Cordillera Valley Club

Design Review Board

Meeting Agenda

Cordillera Valley Club Design Review Board *Staff Memorandum*

EXISTING CONDITIONS SITE MAP LOT 3 & LOT 4 CORDILLERA VALLEY CLUB FILING No. 7 County of Eagle, State of Colorado	
DRAWN BY: PST	DATE: 02/06/2025
CHECKED BY: JRC	DRAWING NO.: 25008
JOB NO.: 25008	SHEET: 1 OF 1

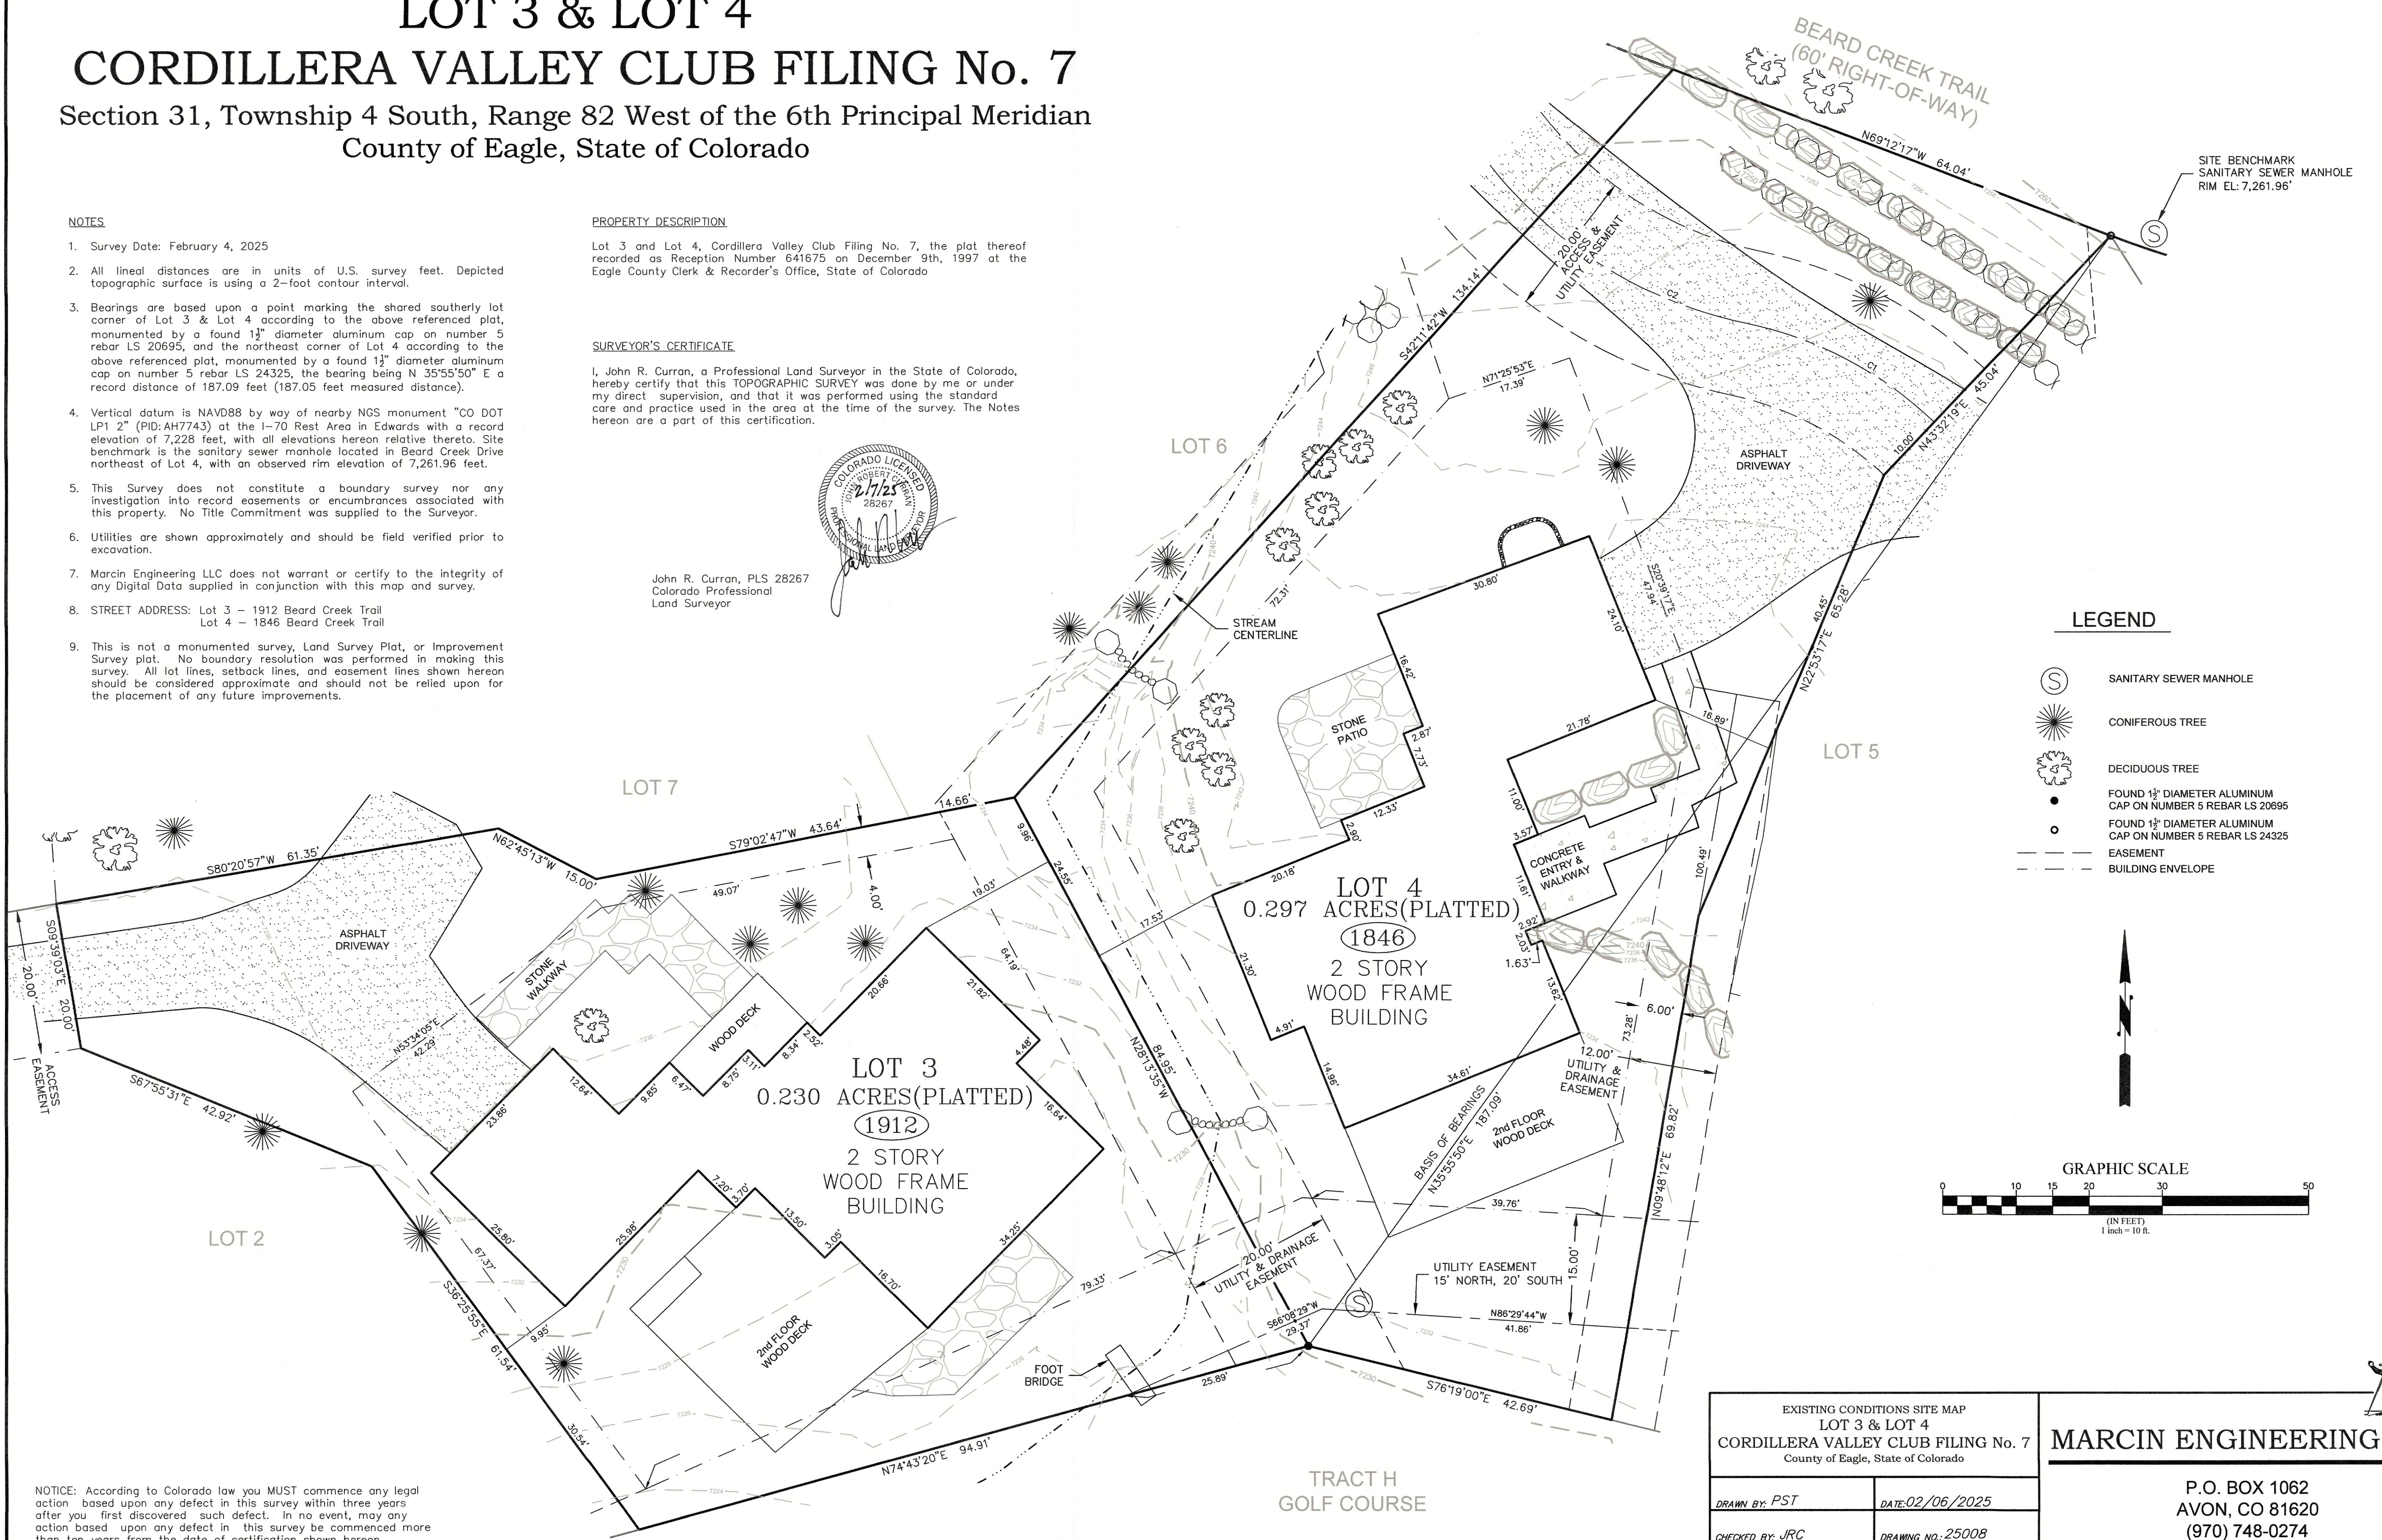
1. Based on the DRB's recommendation, an existing conditions map was provided by a licensed surveyor. Additionally, the applicant provided the information on the location of the adjacent property on Lot 6. This information verifies that the proposed addition is located entirely within the building envelope. An ILC is required at foundation to verify that the improvements have been located correctly.

Drawing Name
EAST EXT. ELEVATIONS

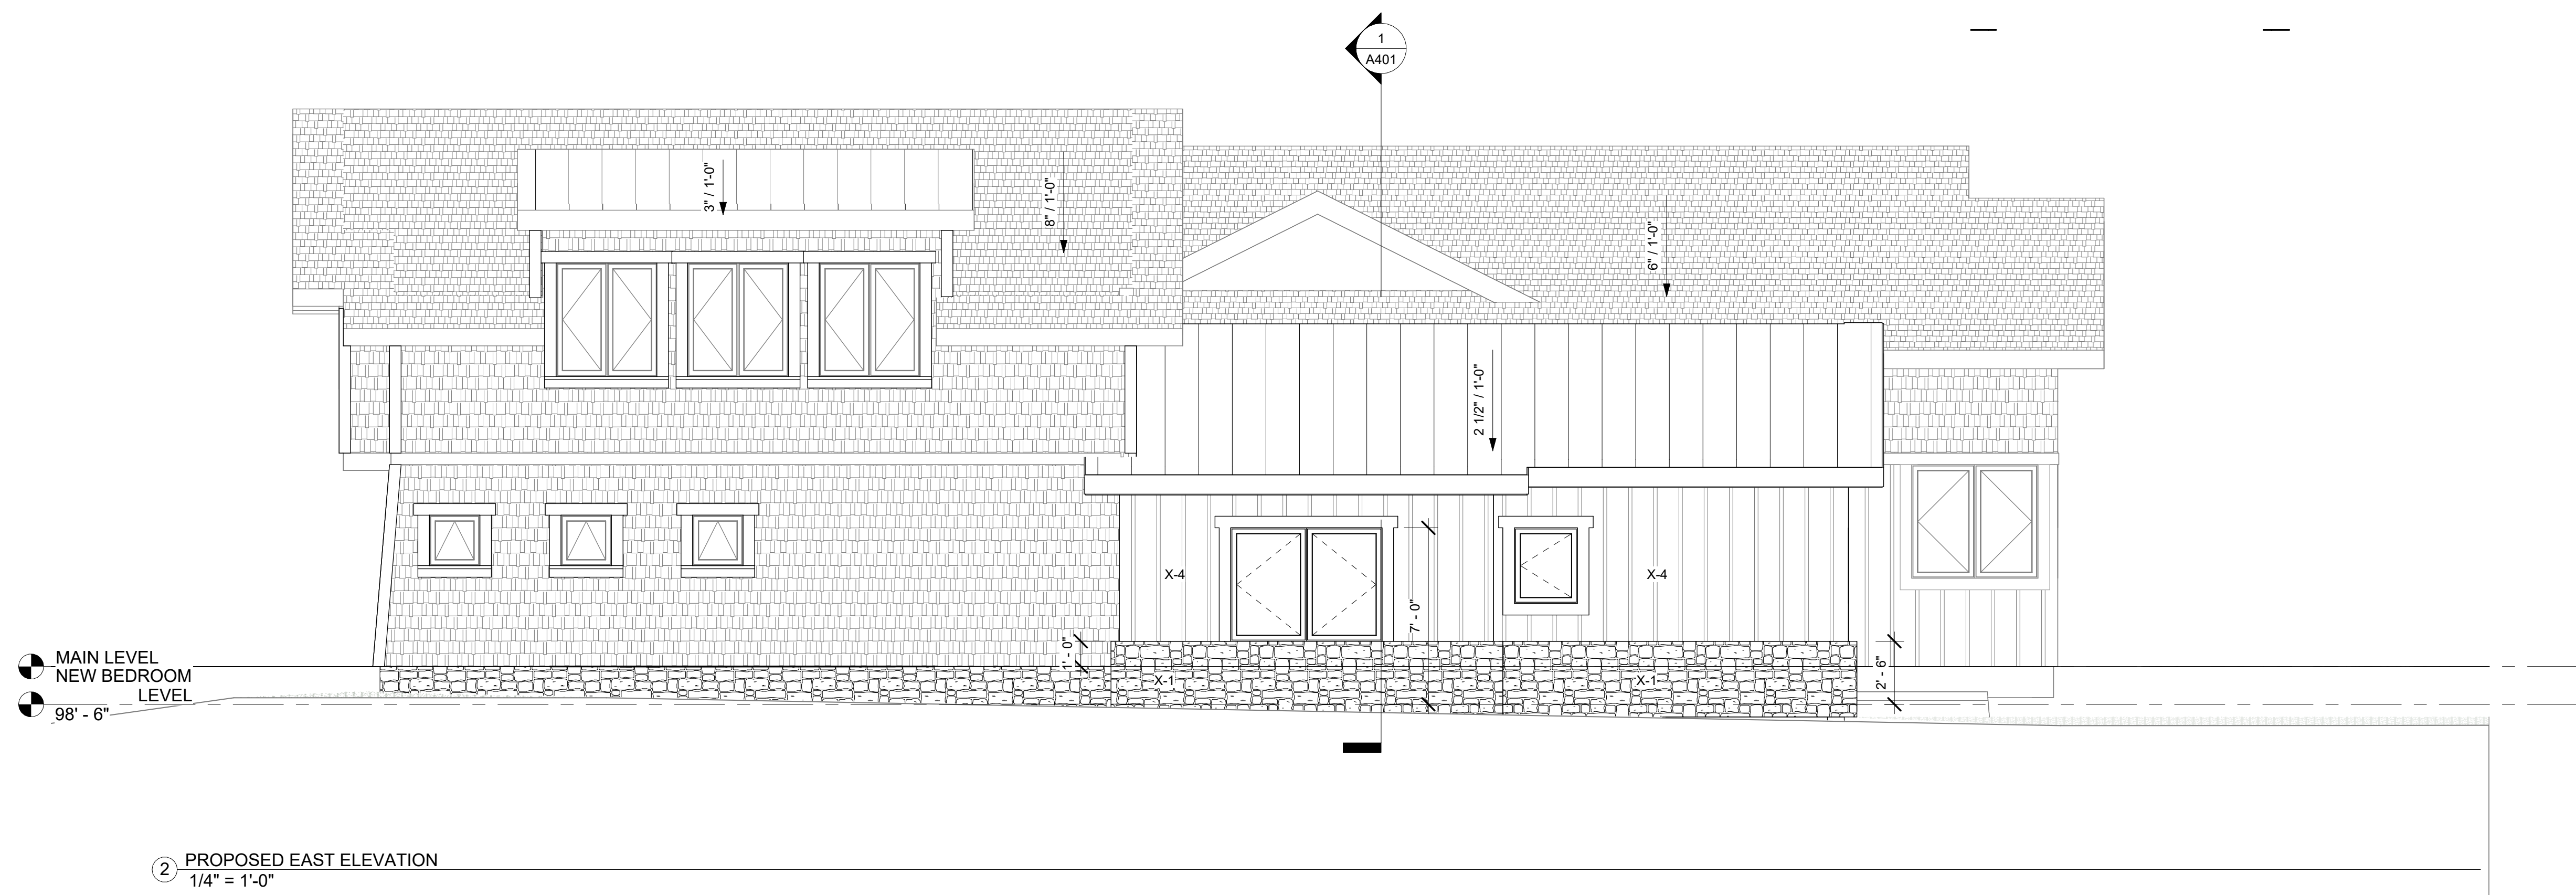
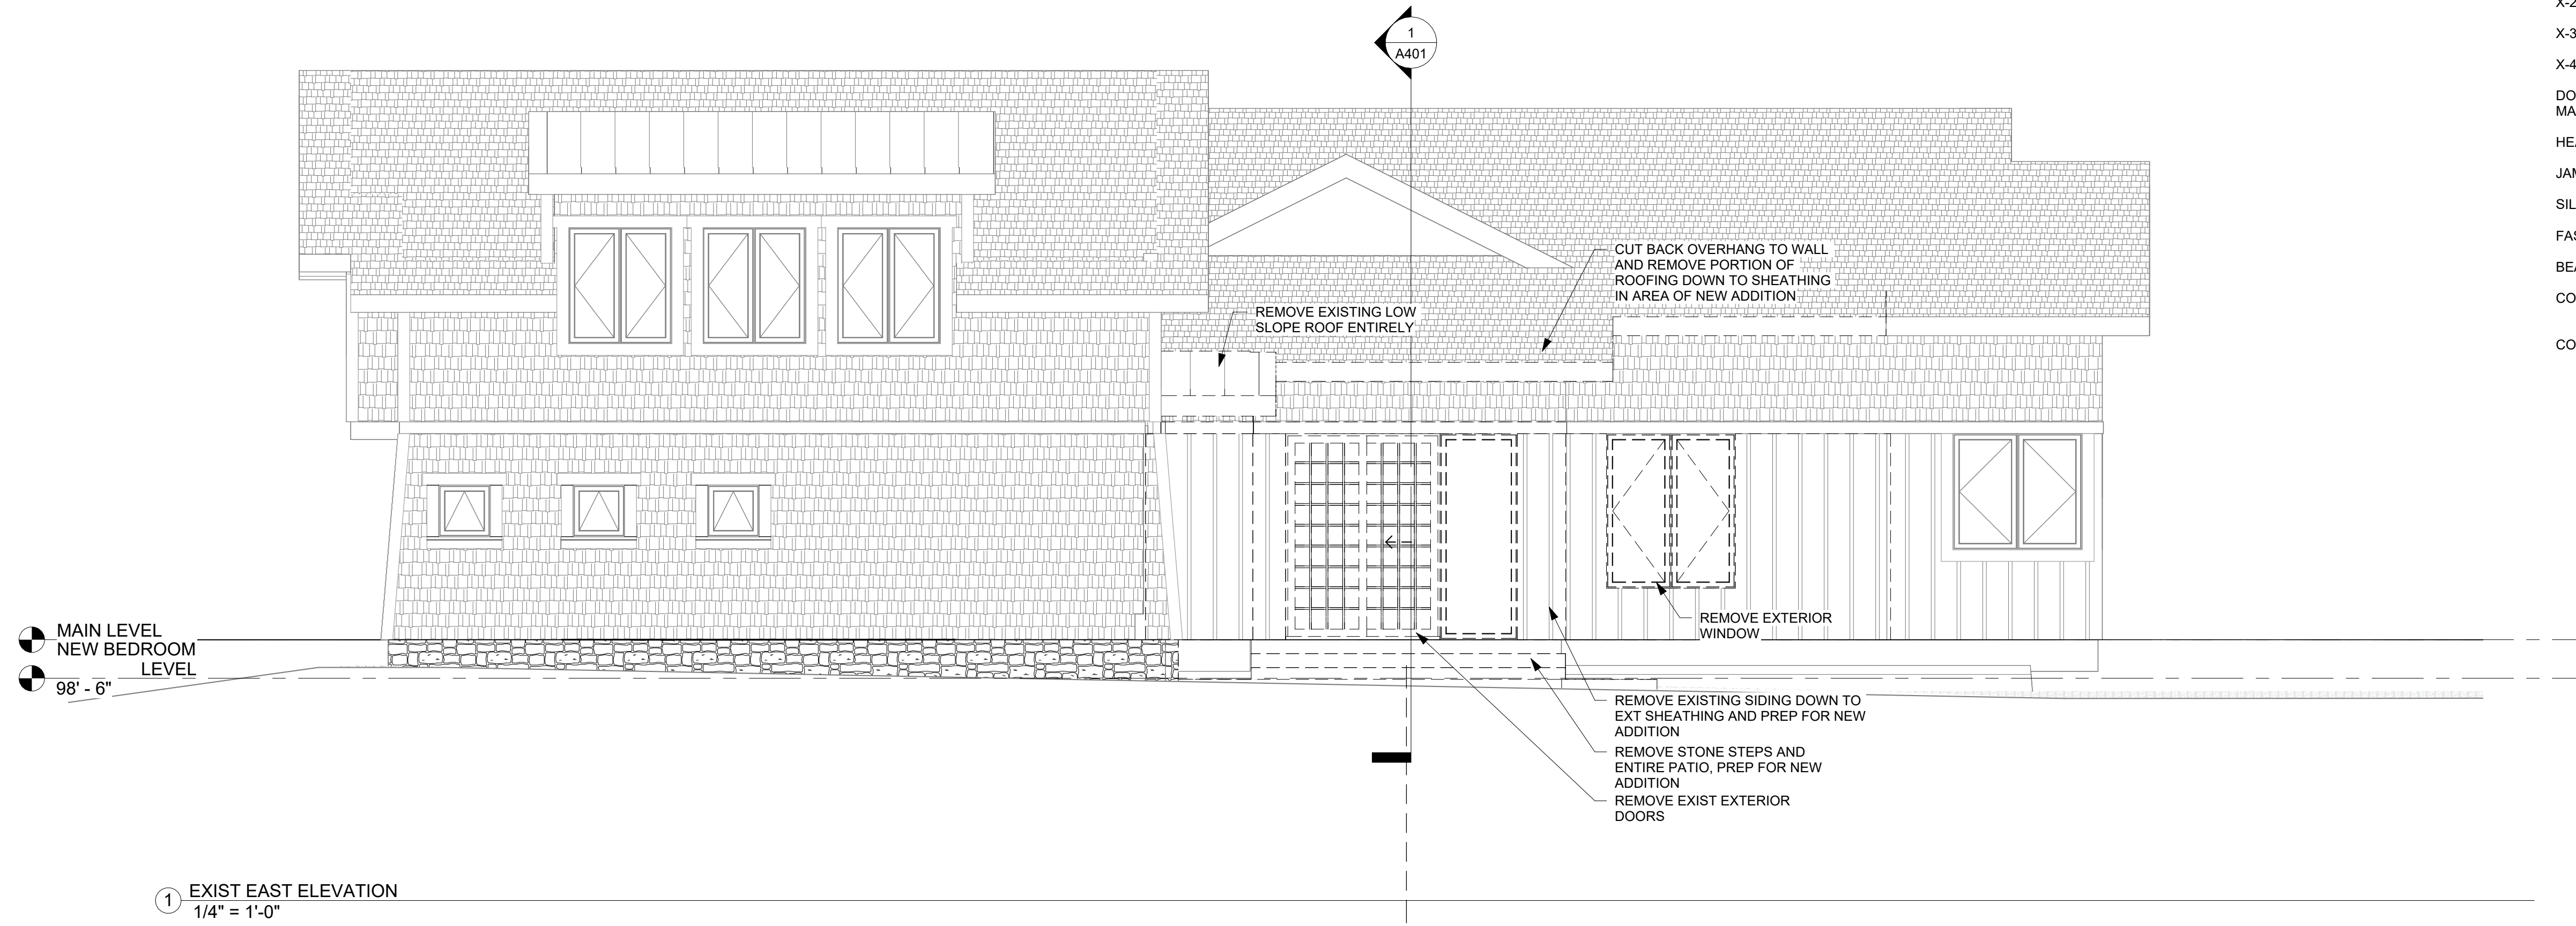
1. The existing 7 Eagles homes have locations where wood siding meets grade. However, due to the extent of the proposed addition, there are now much larger areas where wood siding will meet grade. The Design Guidelines state: "*Wood or metal shall not be allowed to come to grade if it is not at a hard surface. Copper may be used at grade with the approval of the DRB if detailed to function to protect the wall surface as stone would. This exception is meant to be used sparingly throughout the home.*" Exposed concrete foundations are not permitted. The DRB should provide input on the use of stone.

The DRB all agreed that stone should be added to the base of the addition and they were ok with the siding material going to roof line.

1. The proposed addition is now entirely located within the building envelope. Therefore, a deviation from the Design Guidelines is no longer necessary.
2. In response to the DRB's comments on stone, the applicant has now proposed that addition to have a stone base. This is consistent with the Design Guidelines.
3. All colors and materials are proposed to match existing.
